M5 Junction 10 Improvements Scheme

Departures from Standard Report

TR010063 – APP 9.76

M5J10 Departure from Standards Report

DFS 10
RATE OF CHANGE OF
CROSS SECTION IS
LESS THAN 1:35

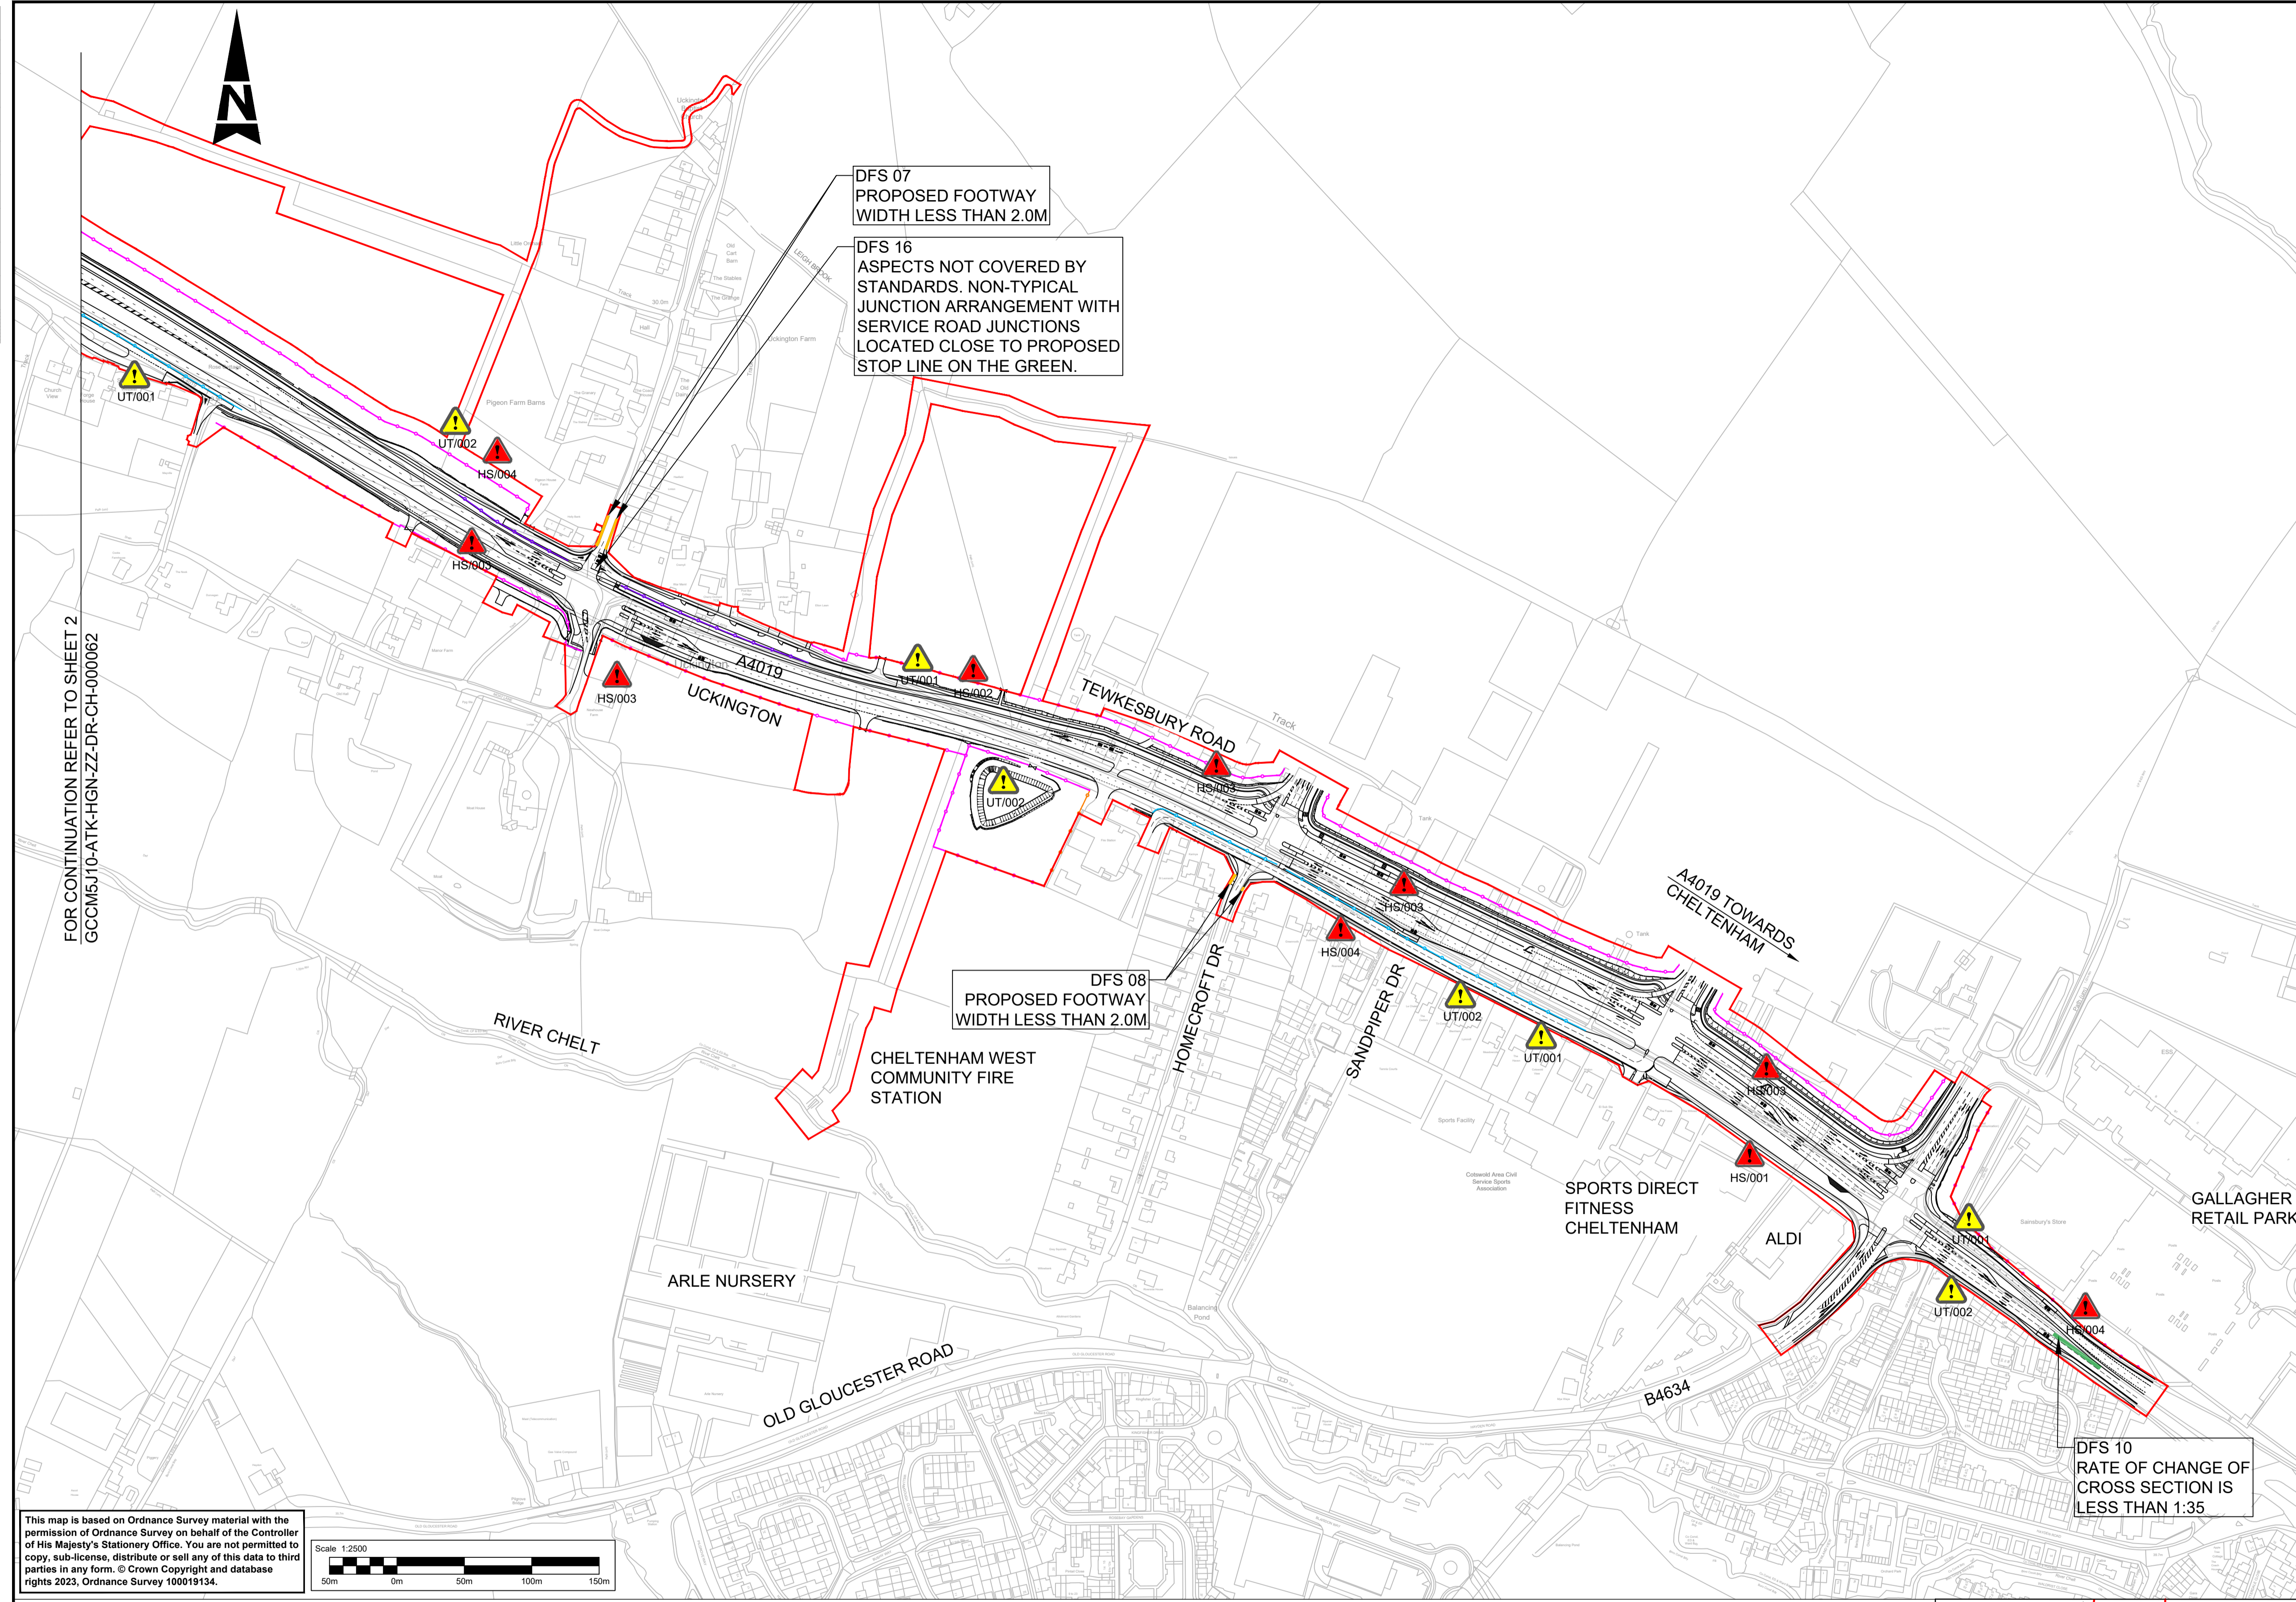
- 7.1.2. The minimum transition tapers for the rate of change in the cross-section width of mainline lanes are set out in DMRB CD 127 Table 2.28. For a 70kph design speed the minimum transition taper is 1:35.

- 7.1.3. Providing the required rate of change of cross section on the new eastbound alignment would require the additional acquisition of land currently occupied by a Sainsbury's store and require the demolition of part of the existing store. This would introduce further costs and likely receive objections.

- 7.1.4. The design proposes a reduced rate of change of cross-section (1:14 taper) to minimise the land requirements and avoid the impacts on the existing Sainsbury's store and the existing junction to the east, which sits outside the scheme extents.

- 7.1.5. Submission for departure to DMRB CD 127 Table 2.28 to provide a rate of change in the cross-section width less than the minimum 1:35 transition taper required for a 70kph design speed.

2.5.2. **POST MEETING NOTES:** CD 127 states that the rate of change of cross-section width for a 70kph design speed should be 1:35 min. Other guidance within CD 123 suggests a taper of 1:5 but only for dedicated turning lanes. This proposed departure is for the introduction of an additional ahead lane so we have therefore considered that the 1:35 taper requirement applies to this.

Drawing Title
**Departure from Standard - DFS.05
Compliant & Non-Compliant
Cycle Gradient along A4019**

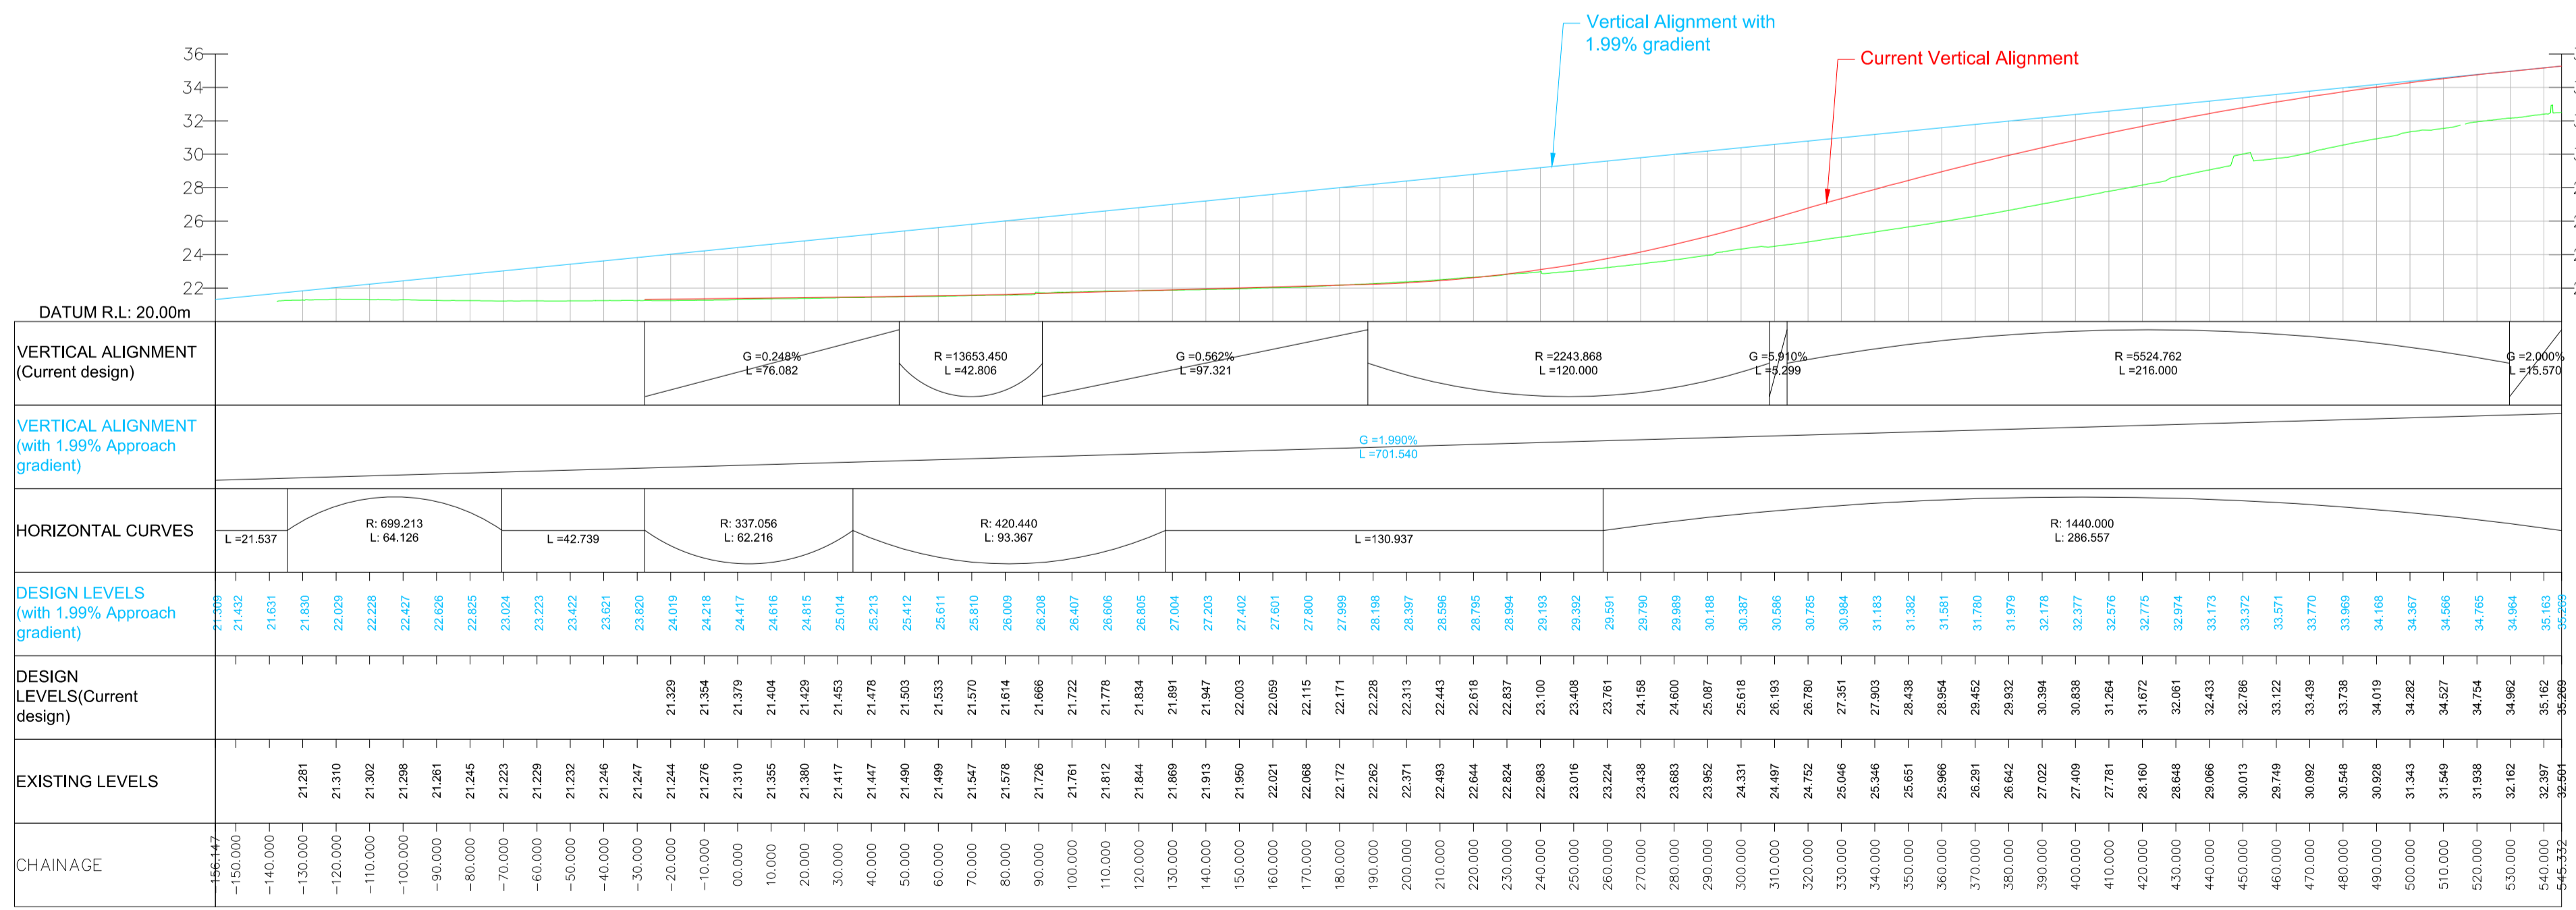
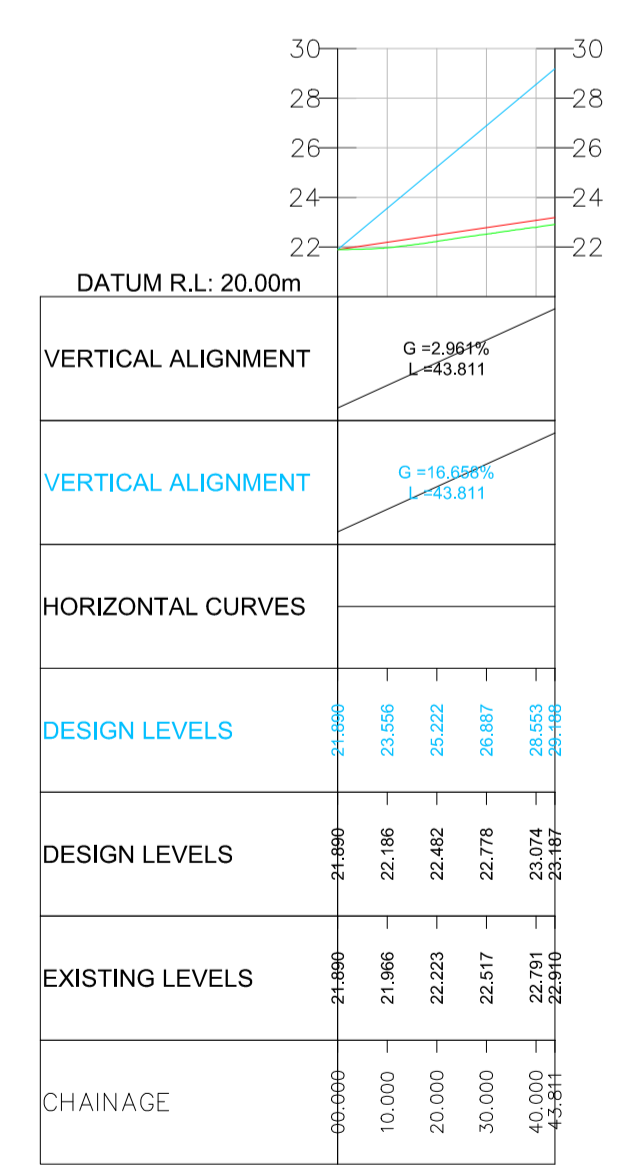
Alignment to be extended to reach ground level with 1.99% gradient

Figure 1-1 – Extract of General Arrangement Plan Showing Proposed Slip/Cycle link Connections

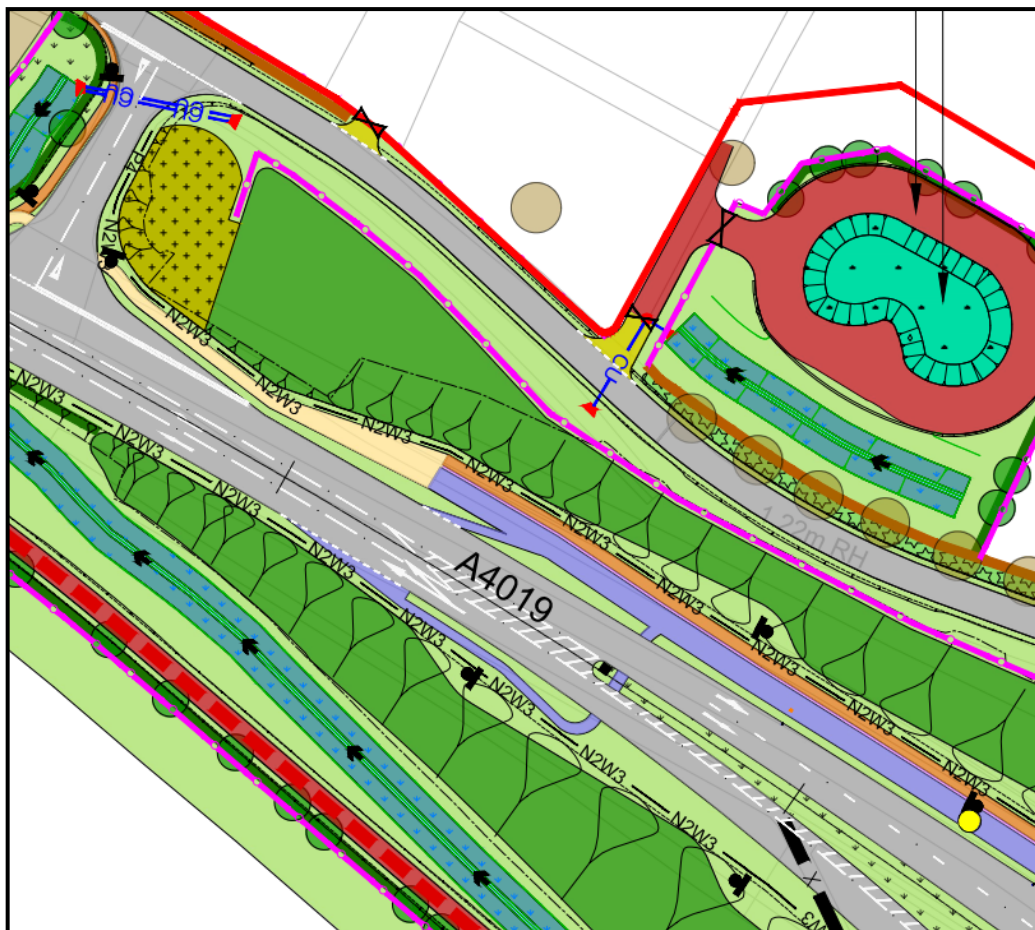
- 2.2.4. For cyclists coming from or heading towards Coombe Hill, the scheme already includes cycle-track to carriageway transitions between the proposed cycle track and both directions of the A4019 carriageway. This proposed facility is located just to the east of Stanboro Lane junction, before the start of the proposed SUP. Figure 1-1 below shows an extract of the General Arrangement of the proposed cycle-track to carriageway transitions at this location.

- 2.2.5. The proposed location of the cycle-track to carriageway transitions offers the advantage of connection directly to the proposed cycle track instead of the SUP. Most cyclists at this location are likely to be confident on-road cyclists as they would typically have negotiated long sections of on-road cycling to get to this point. The slips offer these riders the chance to bypass the M5 J10 roundabout.
- 2.2.6. It is recommended that high-quality wayfinding signs are provided at these cycle-track to carriageway transitions to encourage use of these. If the length of SUP is retained in the design, these signs could also highlight that the proposed SUP connects to Stoke Road but ends at that point without onward segregation for cyclists. This would enable less confident cyclists to make an informed decision about onward travel.
